STREET LIGHTING LAYOUT

PROJECT NAME: BRATTLEBORO
 PROJECT NUMBER: BHF 2000 (17)
 FILE NAME: 94j078\Structures\sj078a117
 PROJECT MANAGER: R. R. WHITCOMB
 DESIGNED BY: G. ROY
 PLOT DATE: 06-FEB-2003
 DRAWN BY: G. ROY
 CHECKED BY: T. SUMNER
 SHEET 30 OF 71

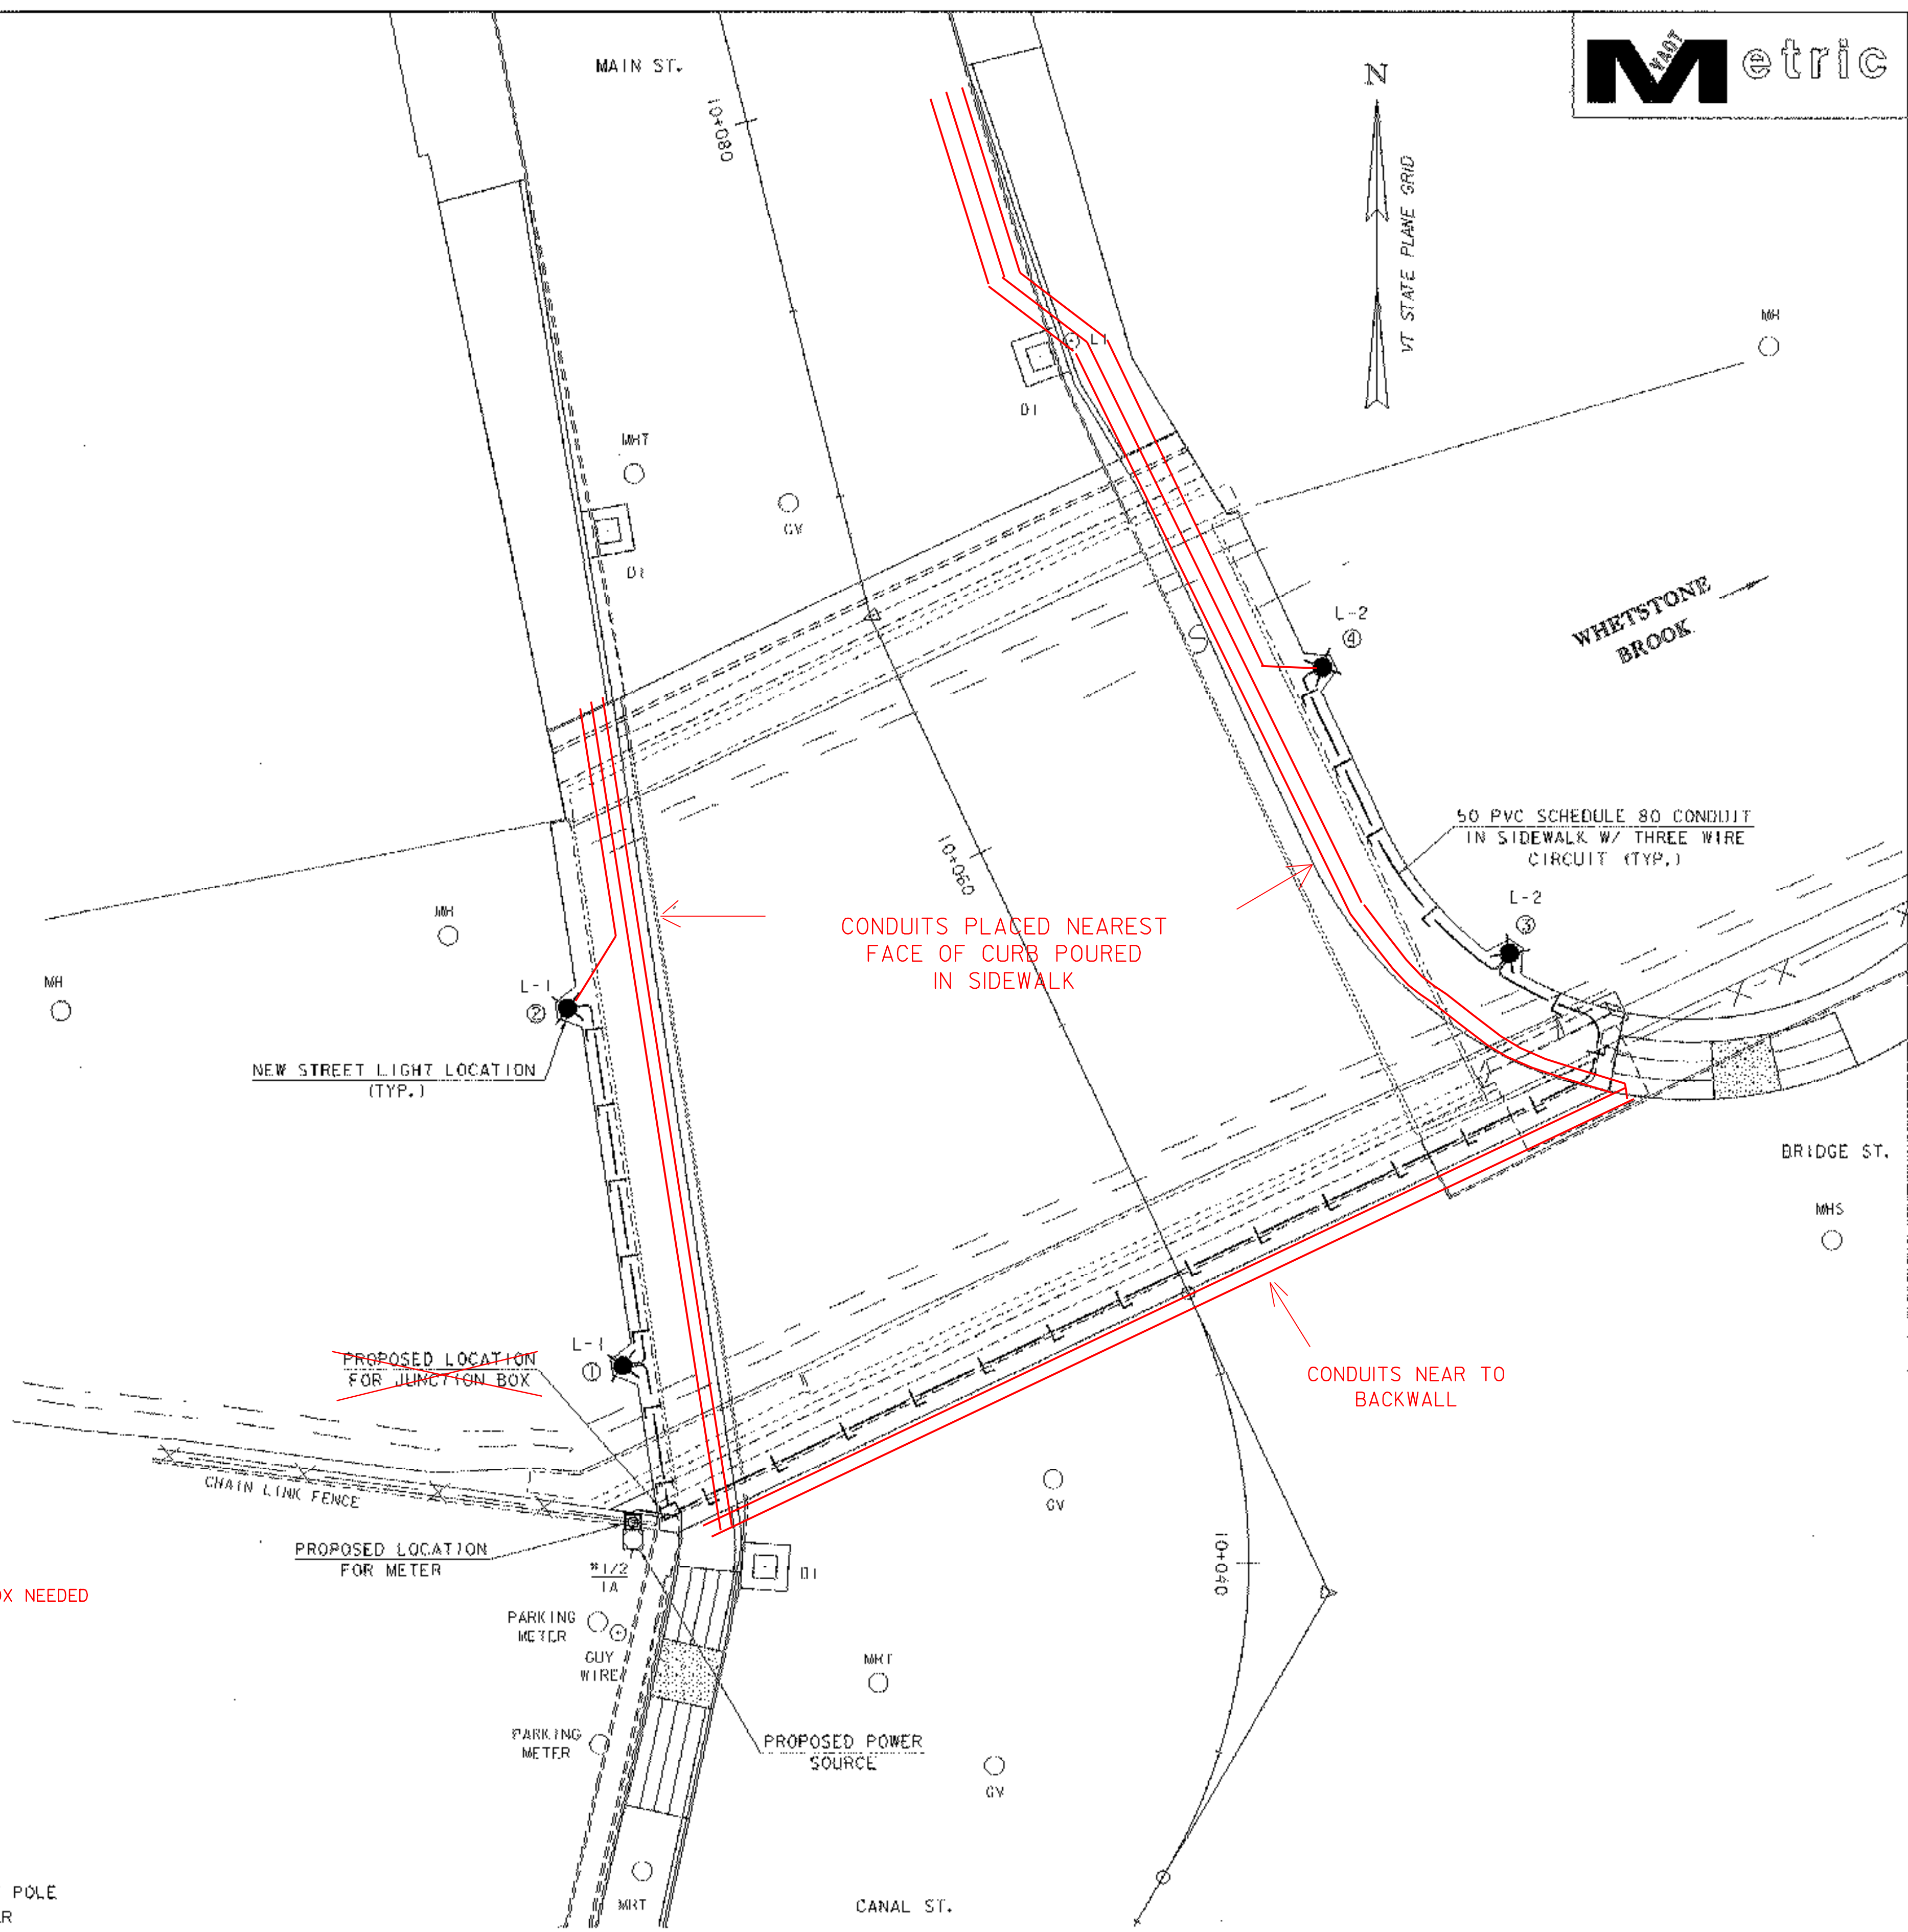
- ONE PHOTOCELL FOR THE LIGHTING CIRCUIT SHALL BE LOCATED AT THE POWER SOURCE OR SOME COMMON POINT, AS DIRECTED BY THE ENGINEER. **ONE PHOTO CELL ON EACH POST**

- IF THE LOCATION OF THE POWER SOURCE, **JUNCTION BOX**, AND METER VARIES FROM THE PROPOSED LOCATIONS SHOWN ON THE PLANS, THE NEW LOCATION WILL BE APPROVED BY THE ENGINEER AND THE TOWN OF BRATTLEBORO.

- INSTALL ALL **JUNCTION BOXES**, THE CONDUIT, PHOTOCELL AND WIRING AS DETAILED ON PLAN DRAWINGS. **NO JUNCTION BOX NEEDED**
 - INSTALL POWER DROP STANCHION, **OPTION #3 - SEE STD. E-175M - ON EXISTING POLE**
